LOS ANGELES COUNTY DEPARTMENT OF PARKS AND RECREATION

PARK OBLIGATION REPORT

REVISED VESTING TENTATIVE TRACT MAP NO. 52047-1

TRAIL REVIEW: TR052047-(1)

Enclosure: Map of Schabarum Extension Trail TR52047-1

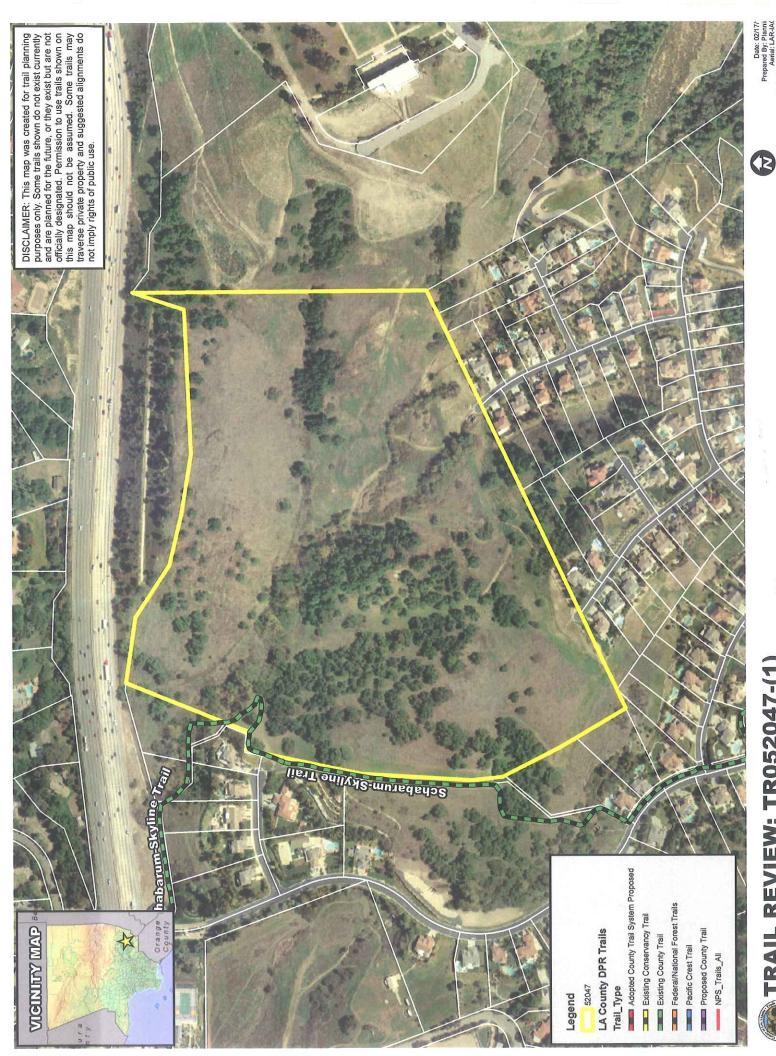
The Department of Parks and Recreation (Department), Trails Planning Section has completed the trail review for Vesting Tentative Tract Map No. 52047-1 (Bridlevast, Inc.). The Department may request revision of the map and the recordation of a twenty (20') foot wide trail easement for multi-use (hiking, mountain biking, and equestrian) purposes, and construction of a seven- ten (7-10') foot wide Natural Trail 1 to be designated as the "Schabarum Extension Trail" (see attached). Hold (HOLD) appears before the requested item.

(HOLD) Subdivider's representative to contact Robert Ettleman in the Trails Planning Section to discuss level-grade trail crossing location options across the proposed "A" Street.
